Changes/Additions Needed After 802.1ASbt/D0.4 (to Produce the Next Draft)

IEEE 802.1 TSN TG
2014.05.09

Fig. 11-8 from 802.1AS-cor-1

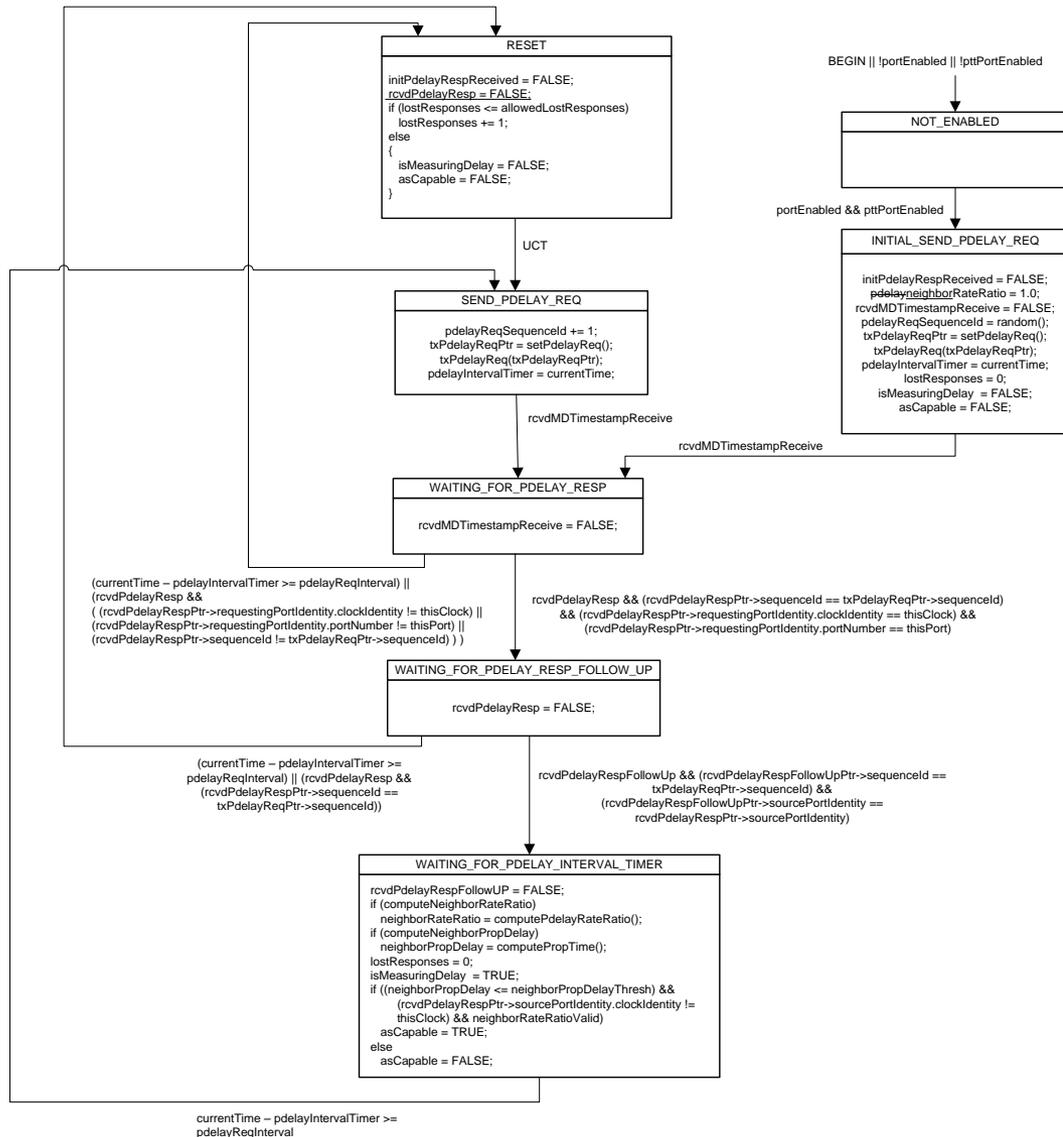
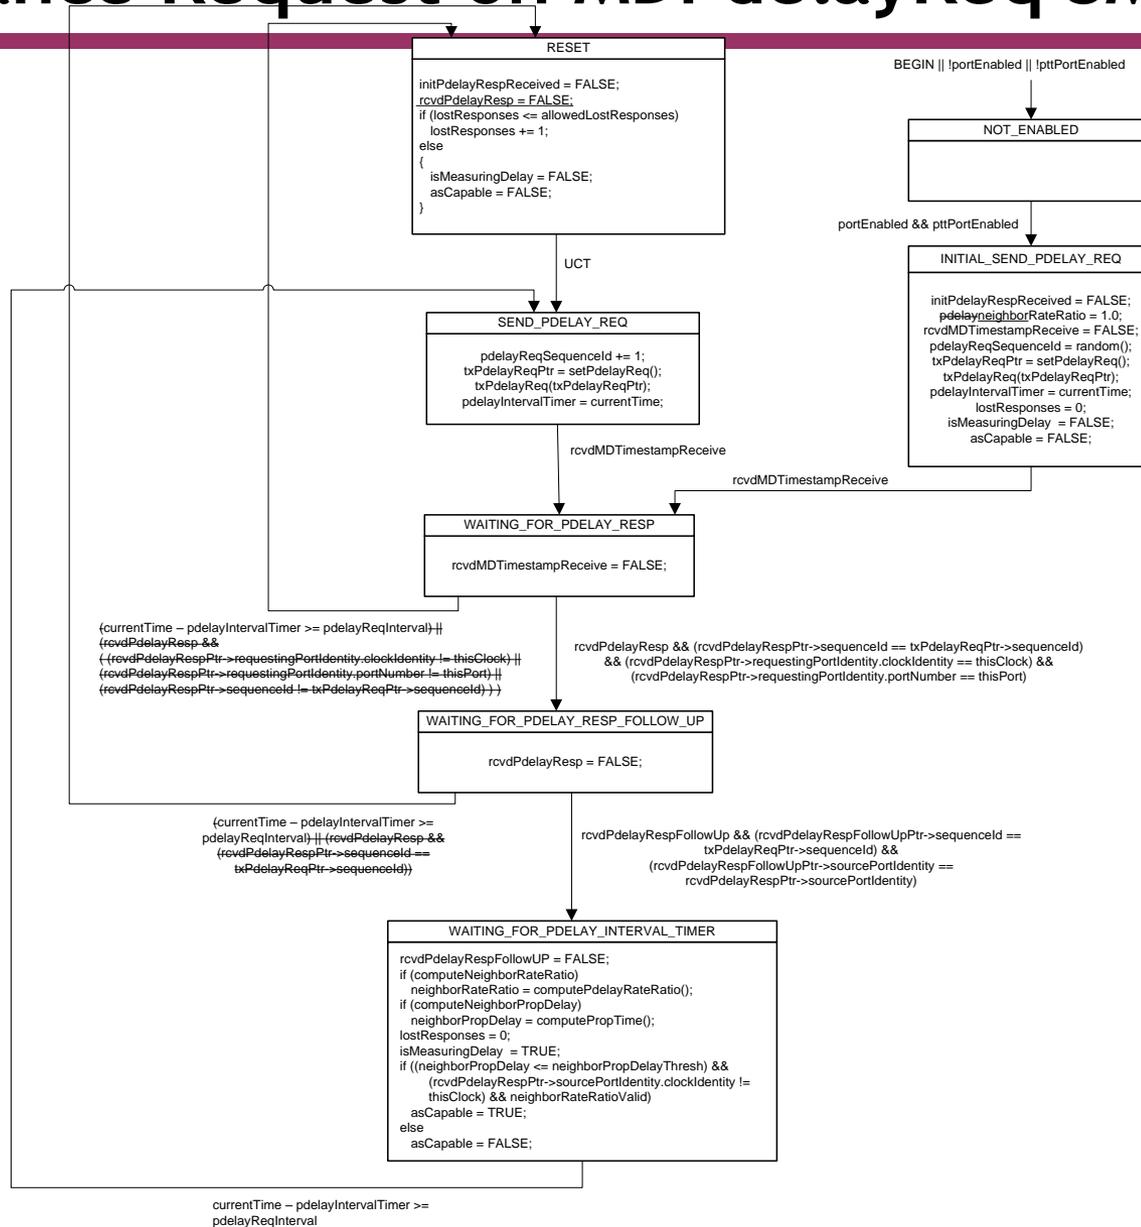
Transitions to RESET due to lost Pdelay_Resp or Pdelay_Resp_Follow_Up occur after timeout

However, transitions due to erroneous frames are instantaneous

This means that persistent erroneous frames sent by responder can cause the requestor to generate a storm of Pdelay_Req messages

- ❑ Since the conditions that check for erroneous Pdelay_Resp or Pdelay_Resp_Follow_Up frames are (or, at least, are intended to be) negations for conditions that cause transitions when correct frames are received, we can simply eliminate the check for erroneous frames, and simply wait for timeout
- ❑ This will cause a delay in entering the RESET state, and therefore a delay before the next Pdelay_Req is sent
- ❑ Proposed modifications to the MDPdelayReq state machine are shown on the next slide
